October 8, 2018

Champlain Towers South
8777 Collins Avenue
Surfside, FL 33154

**Re: Champlain Towers South Condominium
Structural Field Survey Report
MC Job# 18217**

Figure A1: Exterior sealant past its serviceable lifespan at sealant between the window/door frames and masonry/concrete walls & balcony floors

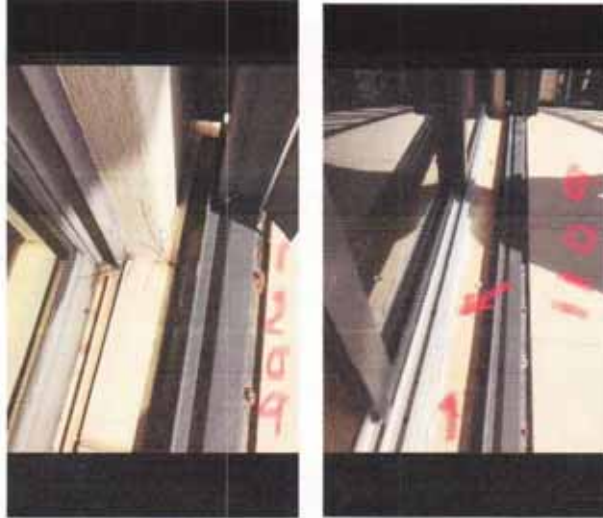
- A. MC understands some unit owners have complained of flooding into the interior space of their unit during a hurricane event. MC has concluded that this infiltration is occurring through the balcony sliding glass doors & windows due to the lack of proper flashing at the sill of these doors & windows and deteriorated exterior perimeter sealant between the window/door frames and masonry/concrete walls. MC recommends that the exterior sealant be removed / replaced at the sliding glass door & window perimeter to assist in providing a water-tight condition. Unfortunately, the new sliding doors in unit 209 and above were not installed properly and were fabricated too tall to allow the base flashing to be properly installed, so these unit owners have no choice but to discard the newly purchased doors and have them completely refabricated.
